Document Version History

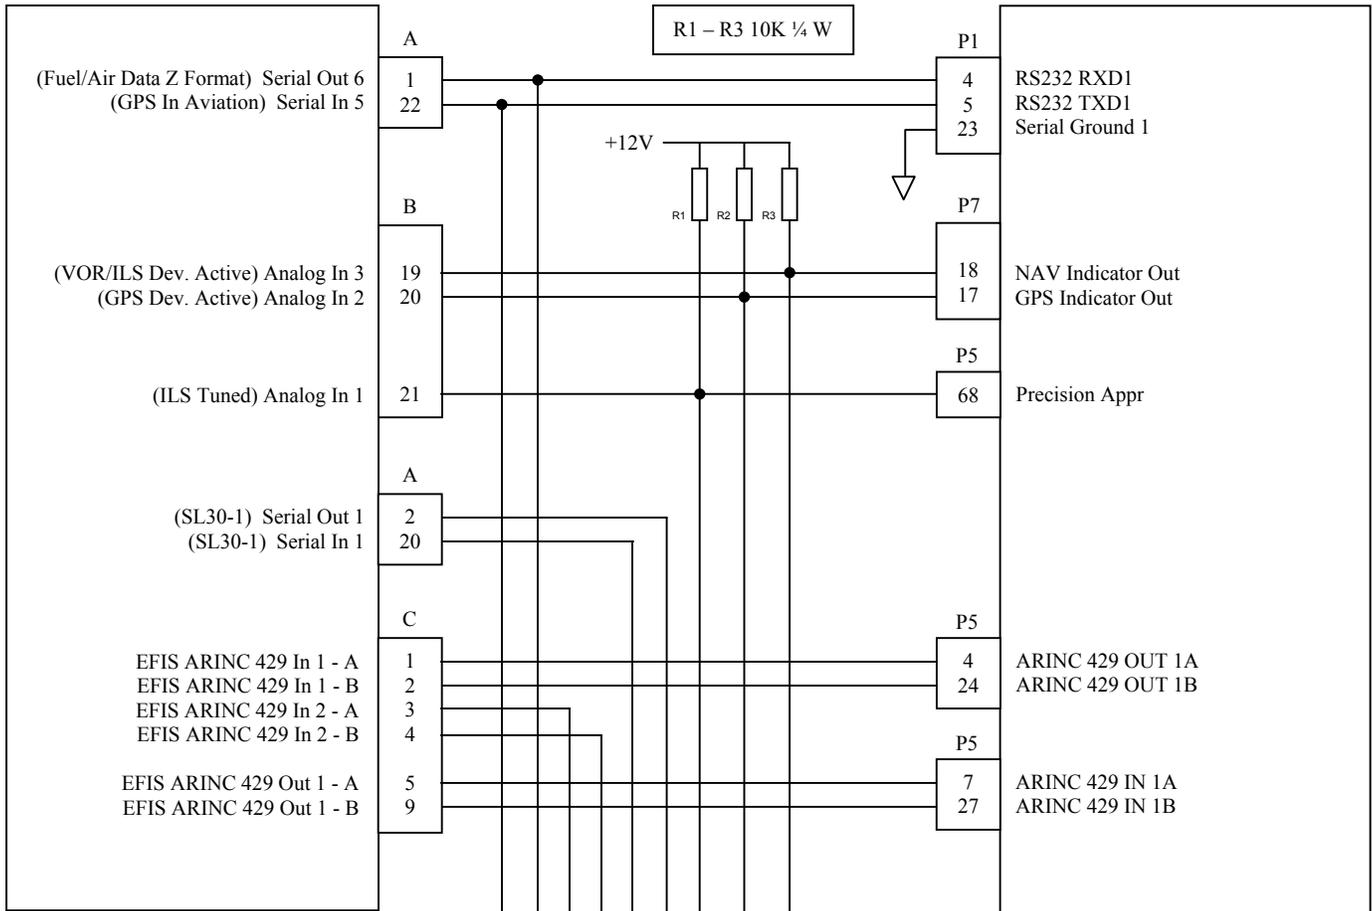
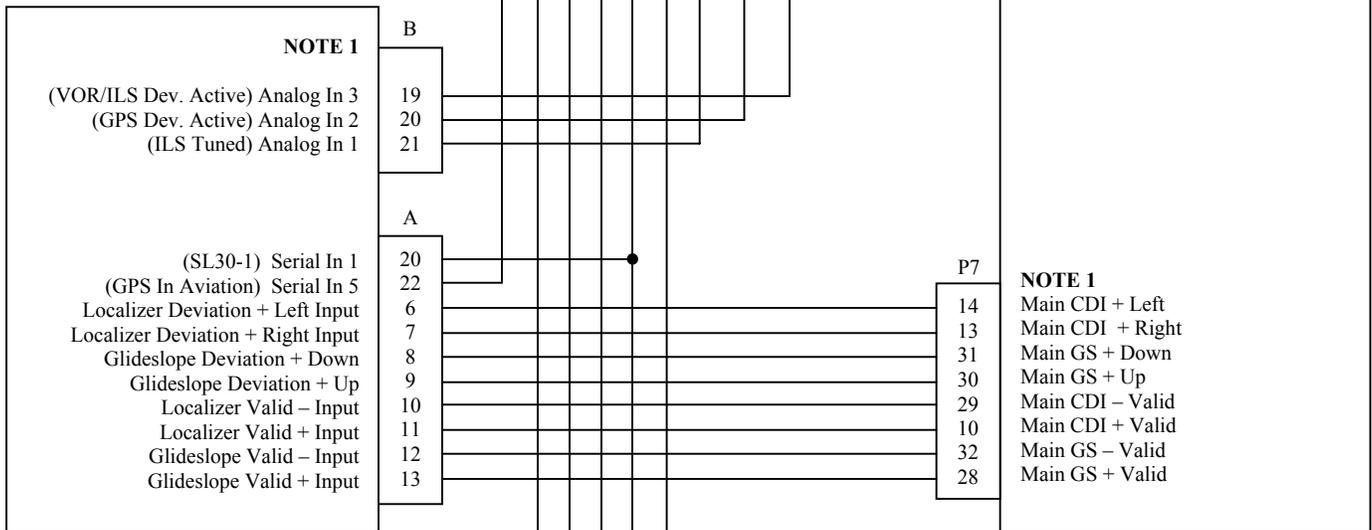
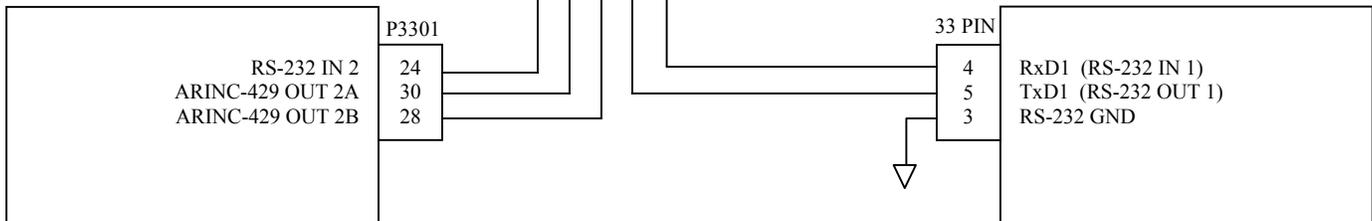
- WD-1002-01 First released version.
- WD-1002-02 Corrected connector A MFD-1 and MFD-2 serial port 1 pin numbers.
Incorrect: Serial Out 1 = A-20, Serial In 1 = A-1
Correct: Serial Out 1 = A-2, Serial In 1 = A-20
- WD-1002-03 Corrected GRT ARINC-429 pin description from Out - 2 to Out -1.
